# Public Submission – SSD-82276962 – 47 Darby Street, Cooks Hill Resident Submission

17 FEBRUARY 2026

Extract from G2 Architectural Plans (elevations/sections). Provided to illustrate overall scale and relationship to context.

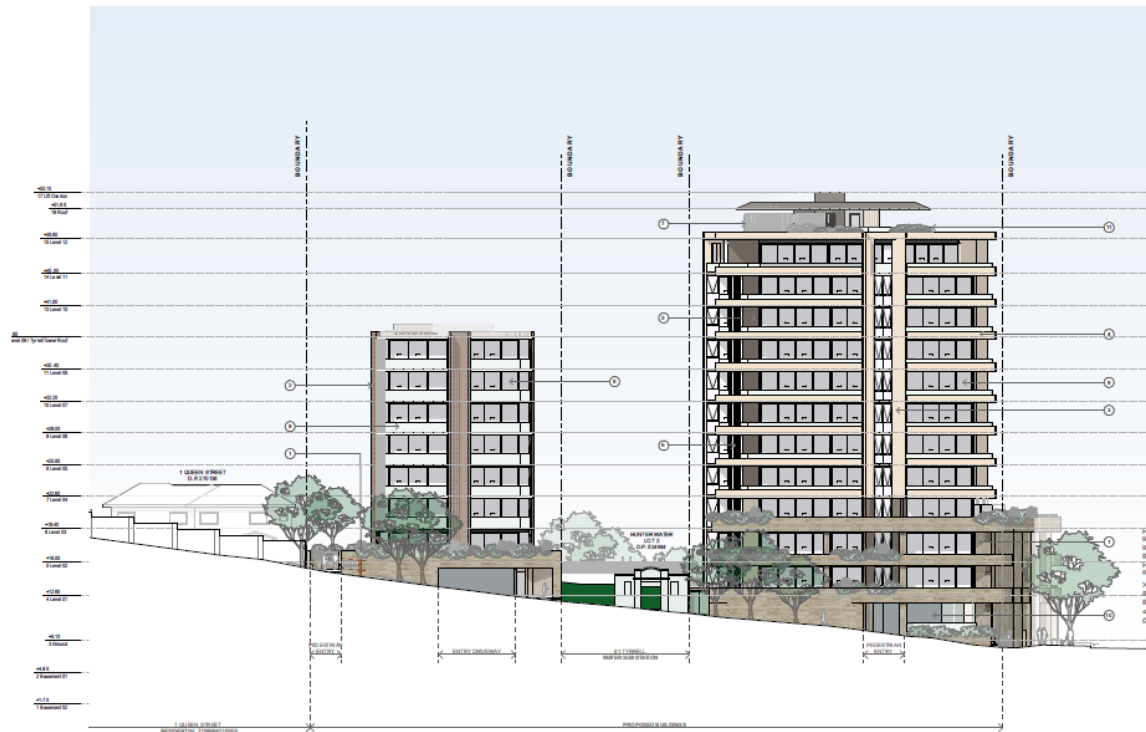
From a resident perspective, the proposal reads as a podium-and-tower development more typical of a CBD high-rise location than a heritage transition edge. The Urban Design material describes the site as an opportunity for a new 'civic landmark'. Regardless of language, a landmark-scale tower will be visually dominant. Extensive design discussion about 'descaling' and 'articulation' indicates the underlying mass is significant and requires mitigation.

**What I am asking for:** A materially reduced height outcome and/or a much stronger step-down/transition toward the residential interface, rather than relying on façade treatment to 'soften' bulk.

Exhibit – Proposed set back (my notes in red) and Alfresco area (only source of light on North facing side)

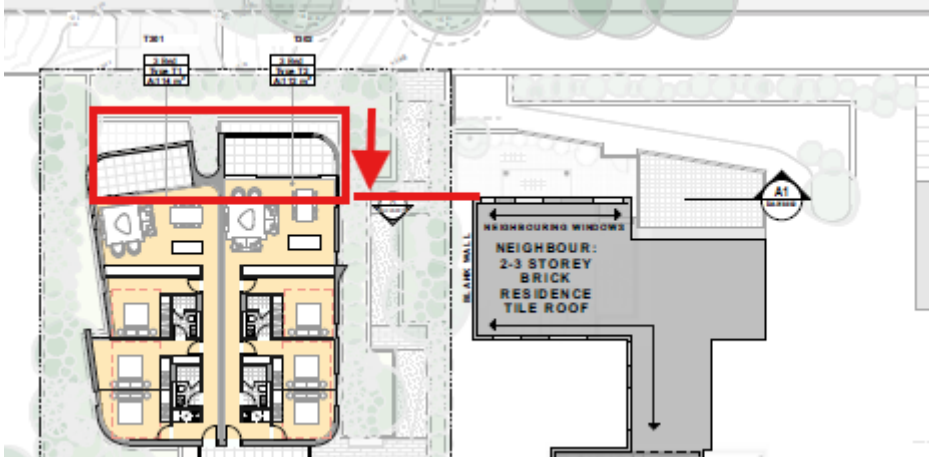
Privacy is not a theoretical issue for me. The Tyrrell Tower extends beyond the line of my alfresco. Balconies and windows directed toward this space will change how we use our home. The Design Report includes privacy mitigation measures (screens, louvres, frosted glazing). While those may achieve technical compliance, they confirm that overlooking is a known risk that requires mitigation.

A key fix is straightforward: the western elevation should be stepped back further so that balconies do not project beyond the plane of my alfresco. This would materially reduce both overlooking and shadowing.

**What I am asking for:** A condition (or redesign requirement) that increases the western setback/steps back balconies to remove direct overlooking to my alfresco, rather than relying primarily on screening.

June 21st Shadow Analysis - Existing, LEP Height Limit & Proposed

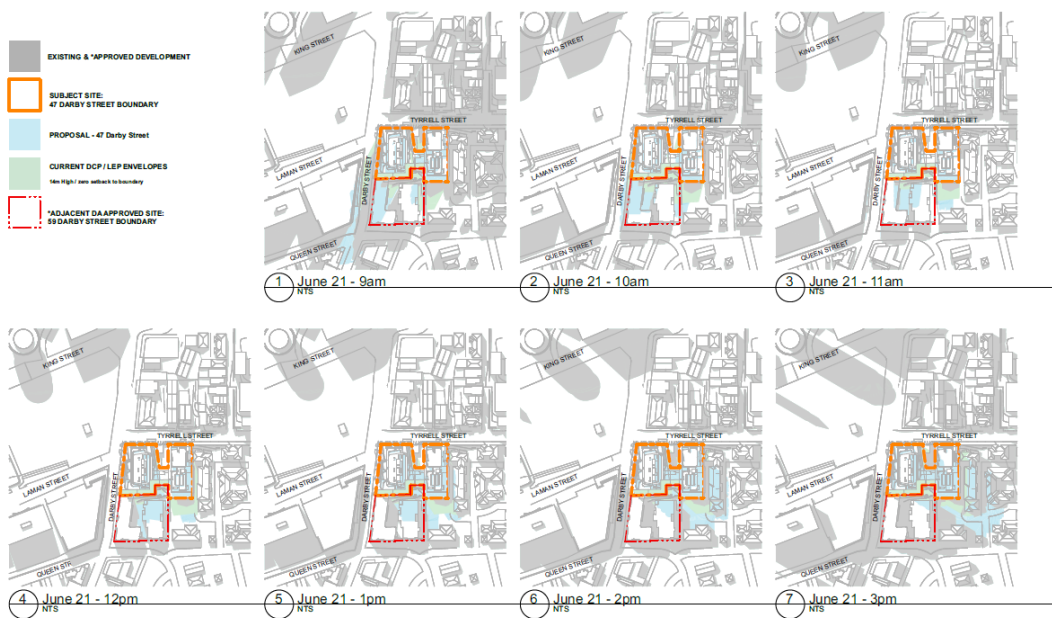
Overshadowing is a key issue for me because our alfresco is our primary outdoor living space and a major source of sunlight. The shadow material provided shows extensive modelling, which suggests shadow impacts are expected to be significant. However, I do not believe the analysis adequately reflects impacts to my specific property and our alfresco

area. I request a reassessment that clearly tests my property (including the alfresco and key outdoor areas) at winter solstice and equinox, with transparent assumptions and receiver points.

**What I am asking for:** Revised/independent shadow assessment that explicitly includes 29/1 Queen Street receivers (alfresco and outdoor living areas) and clearly reports outcomes at key times of day.

I note a material discrepancy in the shadow analysis diagrams. The report states that the figure compares shadow impacts between a 14 m height scenario and a 45 m height scenario. However, the legend and shading shown in the figure indicate only a comparison between the 14 m high residential envelope and a 14 m + 30% affordable housing height allowance scenario. In other words, the figure does not appear to present the claimed 14 m versus 45 m comparison.

This is not a minor drafting issue. Shadow impacts are central to assessing amenity impacts on neighbouring properties, including my alfresco/outdoor living areas. If the figure is intended to support a claim that the 45 m scheme has a particular shadow outcome, then the Department should require the proponent to correct the diagram set and provide an accurate, transparent shadow comparison consistent with the text.

Exhibit – Extract of shadow diagrams. The figure text indicates a 14 m vs 45 m comparison, however the legend appears to show 14 m envelope versus 14 m + 30% affordable housing allowance. This discrepancy should be corrected in the shadow assessment.

- a corrected set of shadow diagrams clearly comparing the 14 m envelope against the 45 m proposed height scheme (same viewpoint, date and time),
- clear legends matching what is actually shown in each diagram, and
- receiver-specific testing for impacted neighbours (including my property at 29/1 Queen Street, The Hill) at winter solstice and equinox.

#### Exhibit – Mine subsidence assessment extract

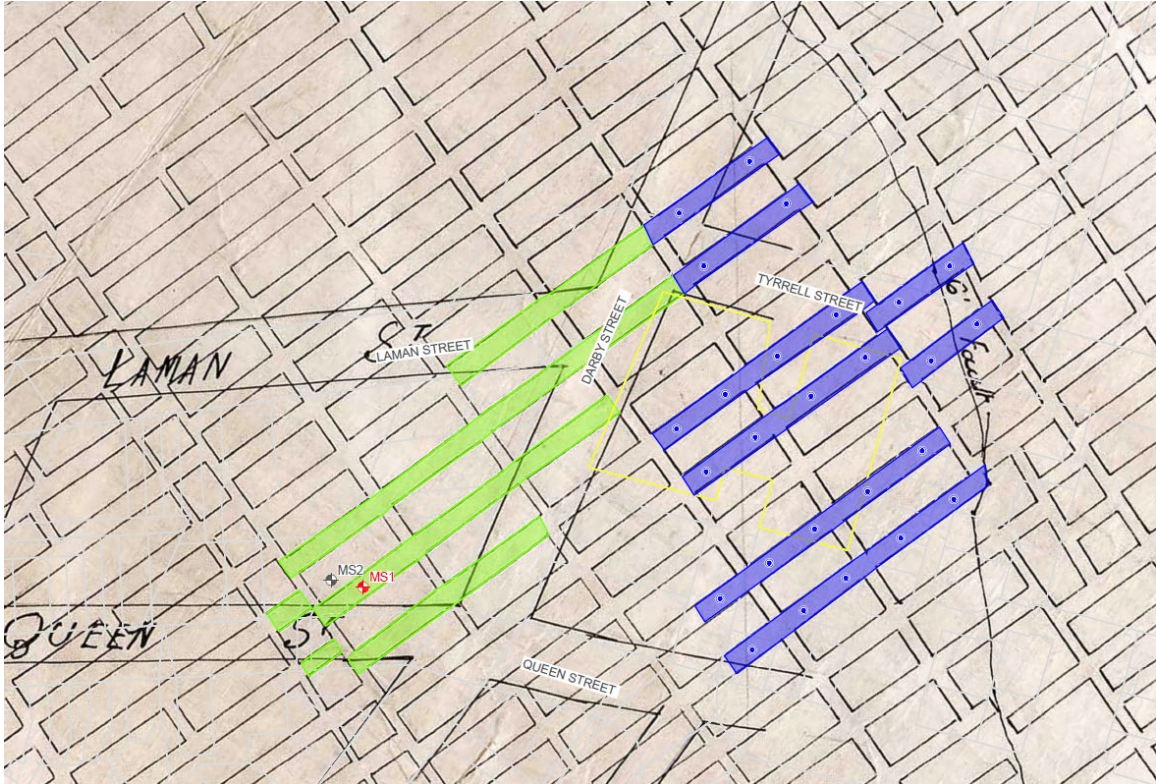
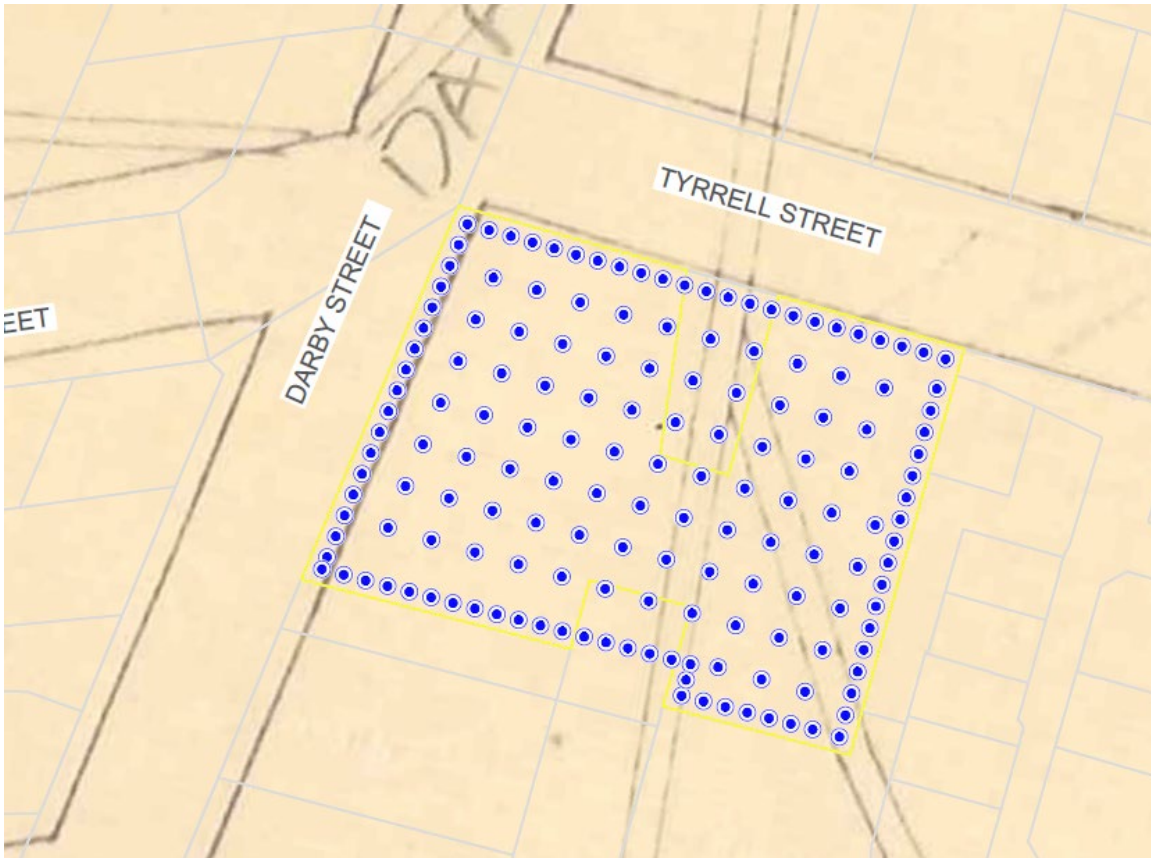
The subsurface conditions are complex. Multiple documents identify mine subsidence risk and the need for significant ground treatment (including drilling/grouting). Basement construction below groundwater level introduces dewatering and ongoing management issues. From a resident perspective, the extent of engineering intervention required to make this site 'work' at the proposed scale is an indicator of overdevelopment.

I am also concerned because diagrams show drilling proposed along the western boundary adjacent to my property, and there are diagrams suggesting potential drill locations

extending into 1 Queen Street association property areas. Residents have repeatedly been told access will not be needed, yet the diagrams create uncertainty. This must be clarified.
